Docket Number:	15-AFC-01
Project Title:	Puente Power Project
TN #:	214330
Document Title:	Applicant's Responses to City of Oxnard Data Requests, Set 6
Description:	N/A
Filer:	Paul Kihm
Organization:	Latham & Watkins LLP
Submitter Role:	Applicant Representative
Submission Date:	11/1/2016 3:45:44 PM
Docketed Date:	11/1/2016

Puente Power Project (P3)
Oxnard, CA

Responses to City of Oxnard Data Requests Set 6

FIGURE 104-1

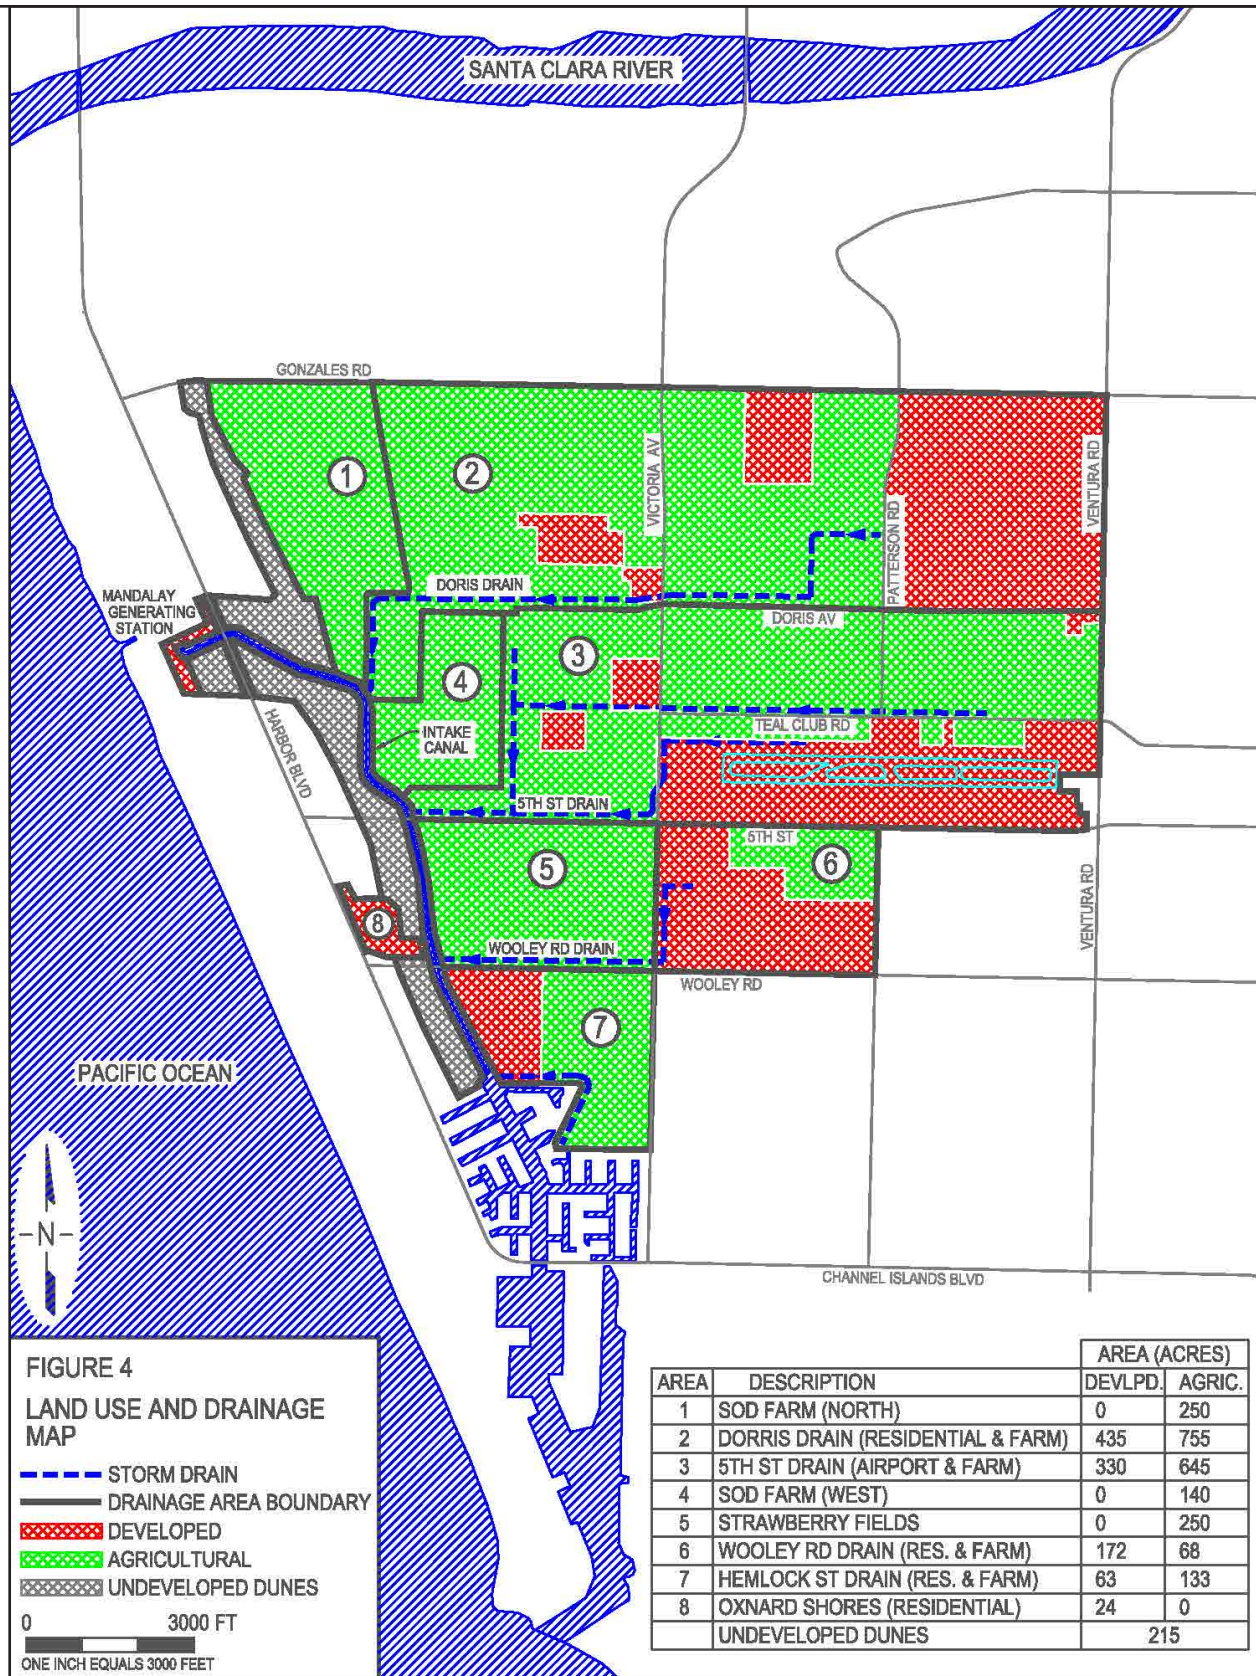
- 104. *The Edison canal receives stormwater discharge from two County of Ventura Watershed Protection District (VCWPD) drainage channels, the West Fifth Street Drain, and the Doris Drain (see attached FEMA map 903F), as well as discharges from surrounding agricultural operations and adjacent properties. What is the canal's drainage design capacity and how much of that capacity do the existing drainages fill? What impact would NRG's proposed discharge have on the canal's ability to accommodate all discharge sources during an 100-year storm event.***

The FEMA map shows the 100-year water surface elevation in the Edison Canal is 8 feet downstream of the West Fifth Street Drain (FEMA FIRM Number 06111C0903F). The ground

surface elevation adjacent to the Edison Canal, based on the Coastal Conservancy Coastal LiDAR, is 14 to 15 feet, resulting in 6 to 7 feet of freeboard in the Edison Canal during a 100-year event. The ground surface elevation along the Edison Canal upstream of the Fifth Street Drain varies from 15 to 17 feet on average, also indicating significant freeboard during a 100-year event. Figure 104-1 shows that the freeboard in the Edison Canal at high tide is approximately 6 to 7 feet at MGS. Based on geometry and the FEMA FIRMs, the Edison Canal would be able to convey the 100-year storm without any flooding, while maintaining 6 to 7 feet of freeboard.
